**Subject:** RE: DA 2022 0084 73 MARINE PARADE AVALON BEACH NSW 2107  
WRITTEN SUBMISSION: LETTER OF OBJECTION #2 SUBMISSION:  
FARRELL & MINITER

SUBMISSION: FARRELL & MINITER

We refer to Amended Plans submitted by the Applicant:

- GT Architect Drawings, Revision B, dated 9 May 2022
- Andrew Davies Landscape Designer, Revision C, dated 12 May 2022

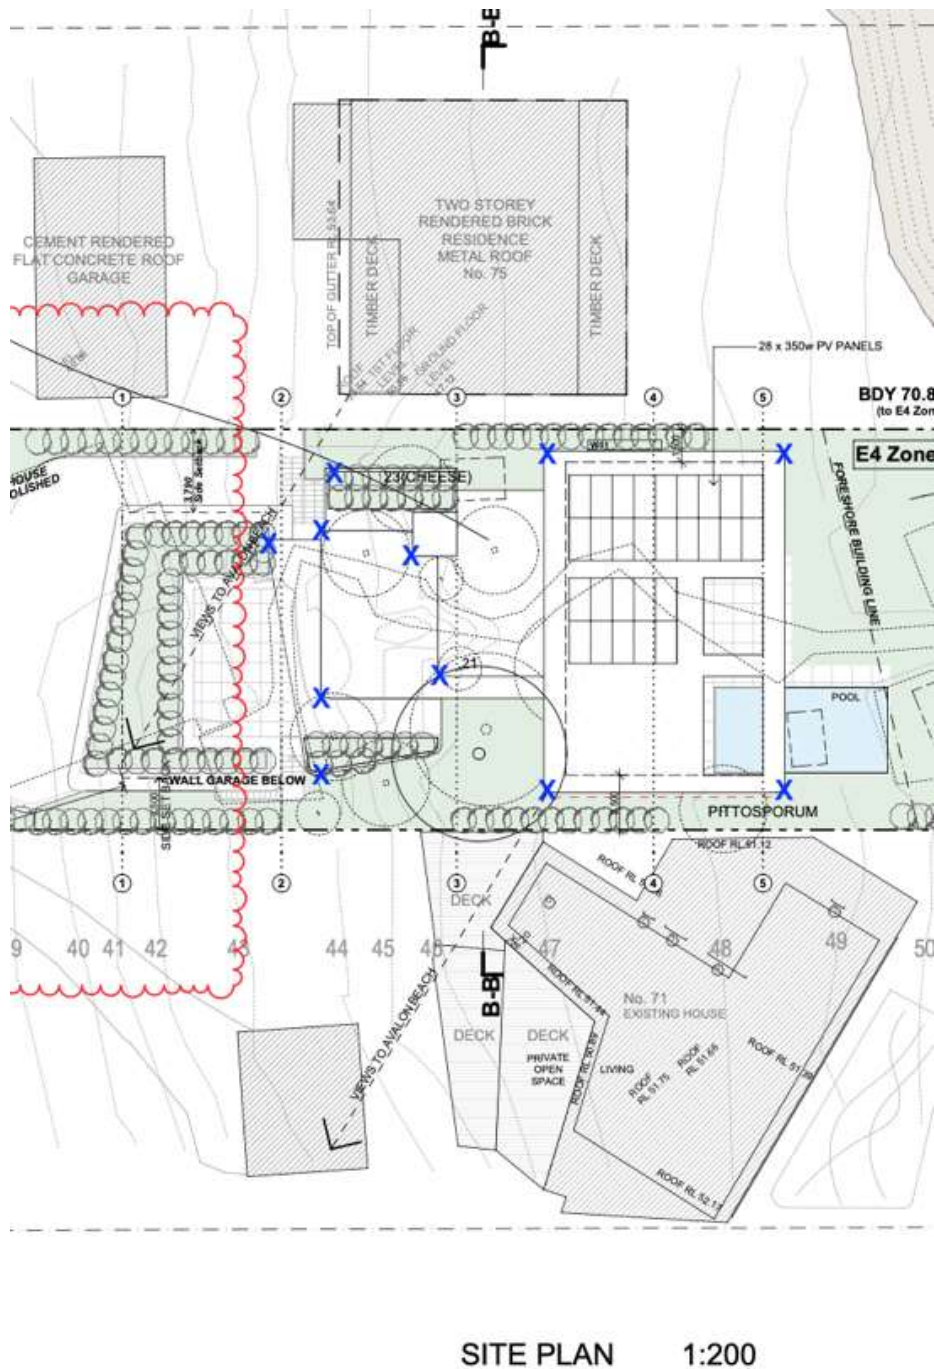
We ask for Height Poles to be erected, at the following locations, identified by the eleven blue crosses in the following Roof Plan diagram. The height poles that have been erected do not define the envelope of the roof forms that are proposed.

The Applicant has not erected sufficient height poles to assess the matter.

We ask Council that after amended plans are submitted to reduce the building envelope to all envelope controls, to request that the Applicant position 'Height Poles/Templates' to define the building envelope, and to have these poles properly measured by the Applicant's Registered Surveyor. The Height Poles will need to define: All Roof Forms, and all items on the roof, Extent of all Decks, Extent of Privacy Screens. Height Poles required for all trees. The Applicant will have to identify what heights and dimensions are proposed as many are missing from the submitted DA drawings.
